STAFF REPORT

To: Edgerton Planning Commission
Fr: Katy Crow, Development Services Director
Re: Application FS2018-04, Final Site Plan for Project Mustang for *Logistics Park Kansas City South First Plat (Project Mustang)* located in the northeast corner of the intersection at 207th Street & Waverly Road.

Requested Action: Final Site Plan for *Logistics Park Kansas City South First Plat (Project Mustang)*.

Map 07 - 2016-05-09
17-0272 Mustang Project Mustang (2017-02-27) Additional Parking

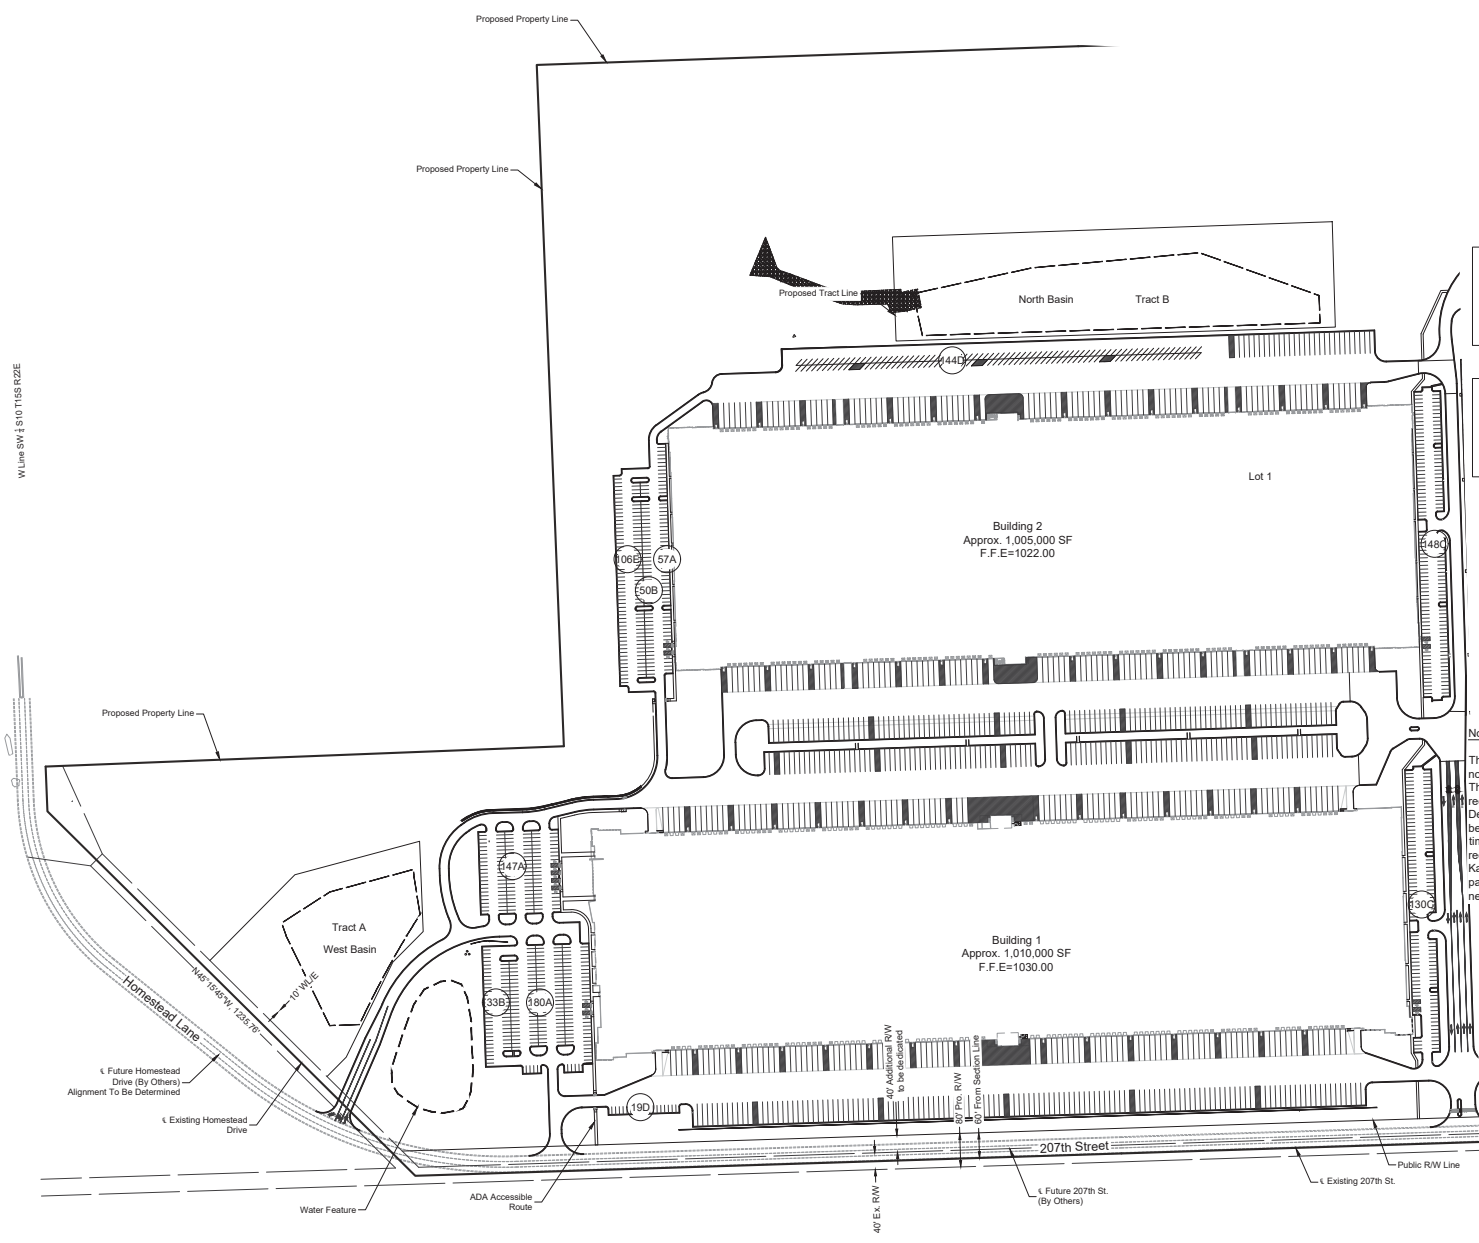
1. Warehouse/Distribution Center and Large Building Parking Space Exceptions. Parking shall be required per City standard based upon individual land use, except Warehouse or Distribution Center land uses, which shall require one (1) space per two thousand (2,000) square feet of building area. *Based upon this requirement, the applicants required number of parking stalls is 1,008. Applicant has provided a Phased Parking Exhibit which indicates a total number of 1,014 spaces are to be built in phases. **Final Site Plan complies. Applicant will add a note to the final site plan to indicate landscaping related to the parking areas will be added with the parking build out.***

Note:
This exhibit is provided for informational and illustrative purposes only and does not constitute a requirement to build the additional parking shown.
The current Final Site Plan application and approved parking study identify the required parking per Section 5.2.K.3 of the City of Edgerton, Kansas Unified Development Code as currently adopted. Any passenger vehicle parking beyond Phase I of this exhibit shall not be required to be constructed until such time as an amended parking study detailing the passenger vehicle parking requirements is prepared by the owner and reviewed by the City of Edgerton, Kansas. At such time, the phasing and location of additional passenger vehicle parking may be altered and/or amended as required to best suit the operational needs of the user and meet applicable code requirements.

Project Mustang Truck Entrance Geometry

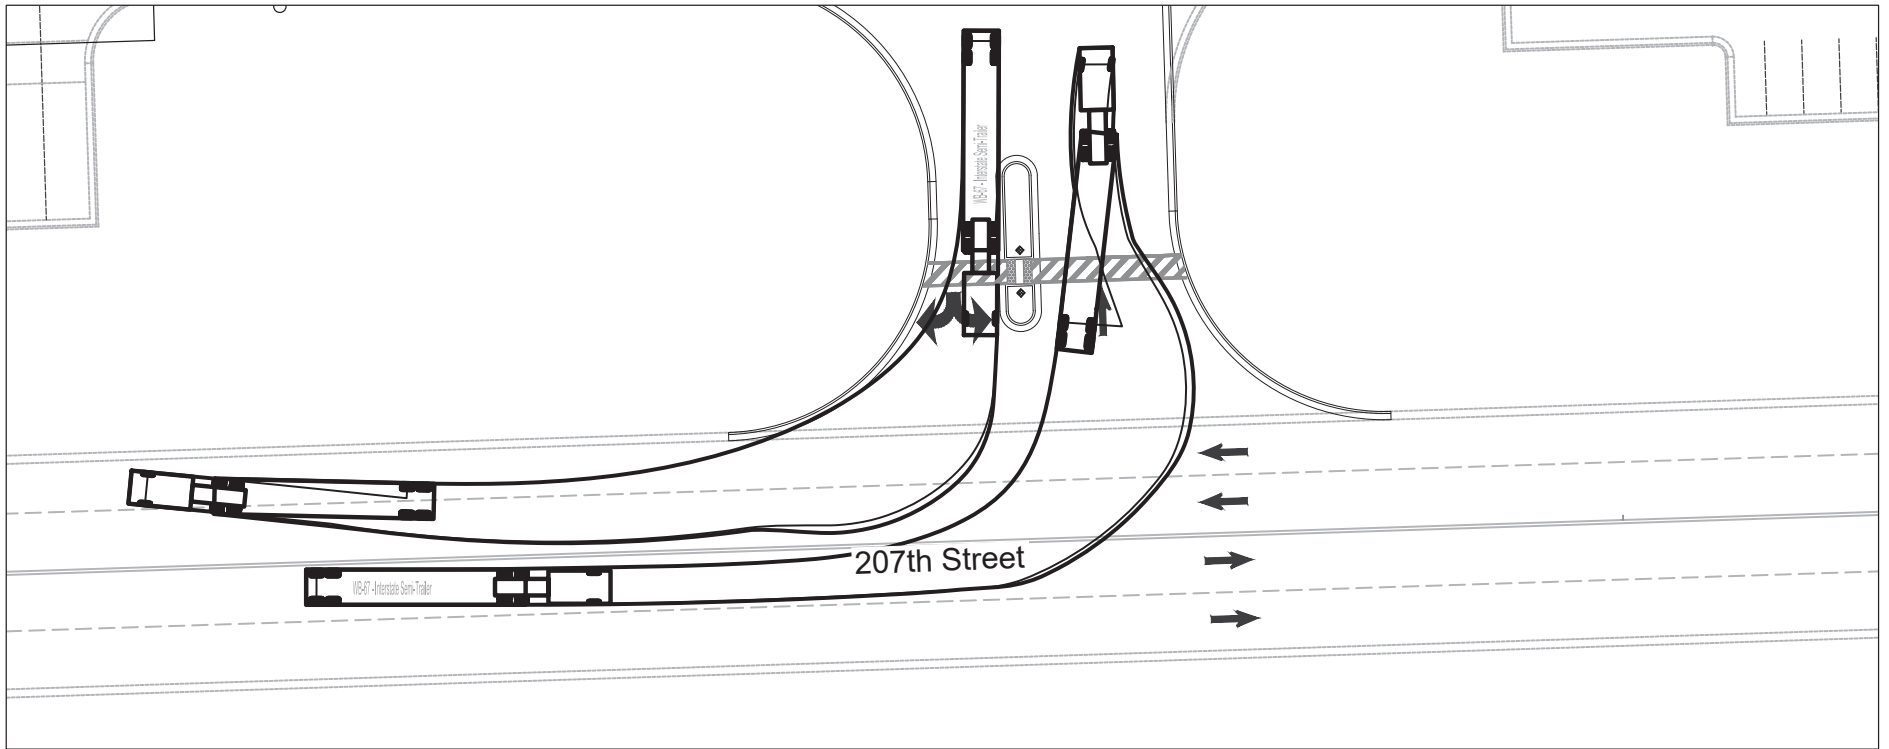
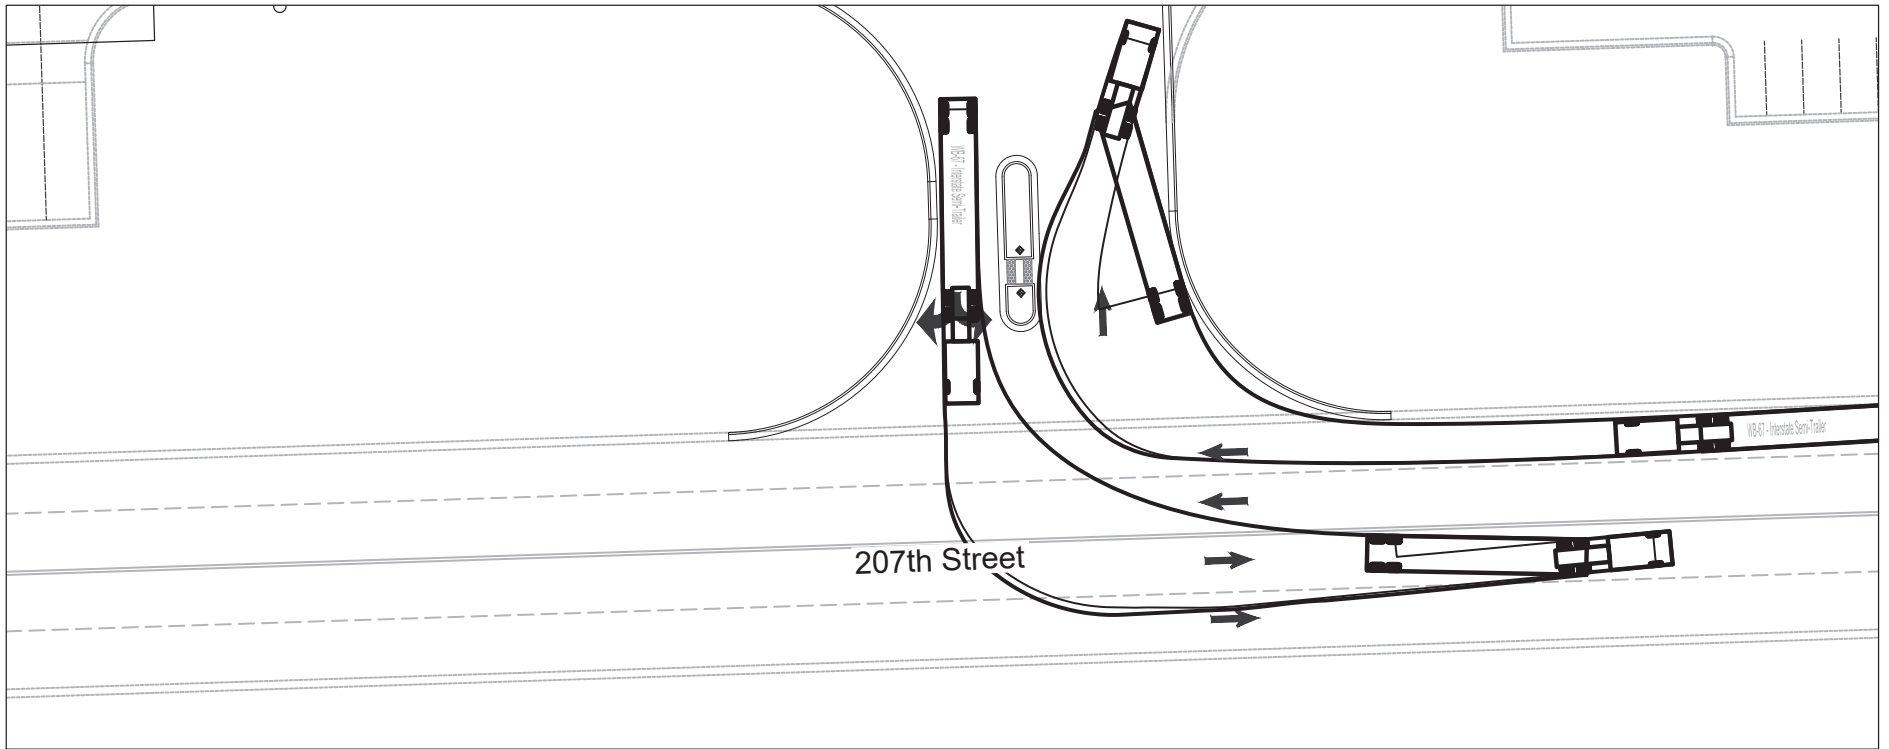
- iv. Site entrance and connections to streets. *During review of the preliminary development/site plan, Planning Commission and staff noted concerns regarding location of access points for passenger vehicles vs. trucks; proposed configuration of the truck entrance along 207th Street, particularly the width; and line of sight and impact of neighboring residences along 207th Street for that truck traffic. Applicant provided memorandum from their engineer along with supporting documentation regarding the location of the truck entrance along 207th Street. Applicant provided line of sight diagram illustrating the proposed truck entrance along 207th Street and its interaction with the residences along 207th Street. Finally, applicant submitted deviation request with support documentation for unique circumstances substantiating the deviation request for larger width along 207th Street. Upon review of all documentation by City Engineer and staff, Final Site complies for location of the truck entrance along 207th Street. Additionally, staff recommends approval of the deviation for proposed width of truck entrance along 207th Street.*

The beneficial user has requested the truck movements be separated from passenger vehicle movements where possible. To satisfy that request, a passenger vehicle only driveway has been proposed at the west side of the project at Homestead Lane and a designated inbound/outbound truck driveway has been proposed at the east side of the project located between buildings 1 and 3. As shown on the proposed final site plan, the tenant has planned for gated, controlled access through a check-in/check-out monitoring system and provides for queuing of inbound trucks on private property. The beneficial user has requested that an inbound, left turning truck from 207th Street not impede the path of an outbound, right turning truck onto 207th Street as these movements can likely occur at generally the same time. To accommodate these movements concurrently, a driveway width of 60' is necessary at the right of way.

1. The east truck entrance would be the predominant truck entrance/exit for the facility.
2. The inbound and outbound trucks will need to be able to freely enter and exit without impeding the movements of the other vehicle.
3. The inbound entrance lane will transition to multiple lanes that would be used to queue trucks on site as they wait for access through the gated, controlled access point.
4. A pedestrian crosswalk and a 6' wide pedestrian refuge area is proposed.
5. The refuge area will include approved striping and signage.
6. A pedestrian easement will be recorded for the public sidewalk extension and crosswalk on private property.
7. Lighting will be provided at the ends of the crosswalk near the curb lines.
